Access Compliance Report

Public Rights-of-Way

(Curb Ramps)

Intersection ID: 49927	Main Street: ASHBOURNE_HALL_RD	Cross Street: CAMPBELL_HALL_CT	Location: NE
ADA ID: 2A30CA0557D4	Ramp Type: Perp	Initial Pass/Fail: Fail	Overall Compliance: No
Severity Score: 1.25			
Codes/Mitigation Info/Possible Solution		Field Measurements/Component Compliance

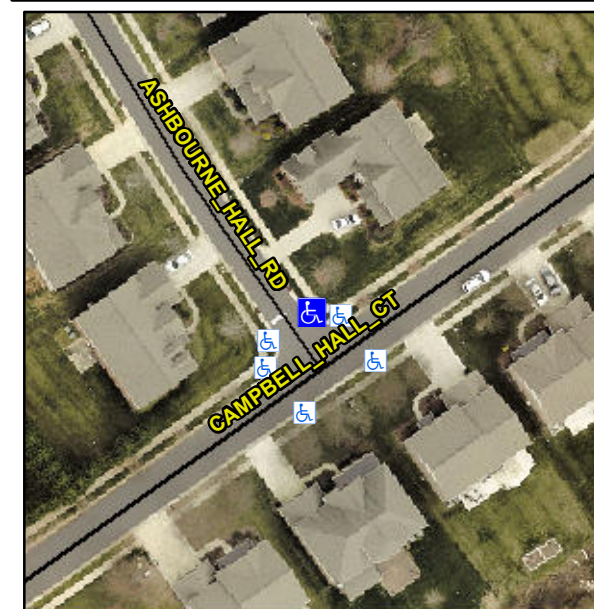
Not Found, R304.5.3

Compliance	Description	Data	Compliance	Description	Data
N/A	Ramp Length (in)	49.0	Yes	Ramp Slope (%)	8.2
Yes	Ramp Width (in)	48.0	No	Ramp XSlope (%)	2.9
N/A	Flare Type LT	N/A	N/A	Flare Type RT	N/A
N/A	Flare Slope LT (%)	N/A	N/A	Flare Slope RT (%)	N/A
N/A	Flare Traversable LT?	N/A	N/A	Flare Traversable RT?	N/A
N/A	Landing Length (in)	N/A	N/A	DWS Provided?	N/A
N/A	Landing Width (in)	N/A	N/A	DWS Contrast?	N/A
N/A	Landing Slope (%)	N/A	N/A	DWS Length (in)	N/A
N/A	Landing X Slope (%)	N/A	N/A	DWS Full Width?	N/A
N/A	Landing Curb? (Y/N)	N/A	N/A	DWS Offset (in)	N/A
N/A	Shared Landing?	N/A			
N/A	Gutter Ponding?	N/A	N/A	Gutter Slope (%)	N/A
N/A	Gutter Lip Ht (in)	N/A	N/A	Gutter X Slope (%)	N/A
N/A	Painted X Walk1?	No	N/A	Painted X Walk2?	N/A
	X Walk 1 Direction	To SW		X Walk 2 Direction	N/A
N/A	X Walk 1 Width (in)	N/A	N/A	X Walk 2 Width (in)	N/A
	X Walk 1 Slope (%)	2.9		X Walk 2 Slope (%)	N/A
	X Walk 1 X Slope (%)	3.0		X Walk 2 X Slope (%)	N/A

Remove & Replace Entire Ramp.
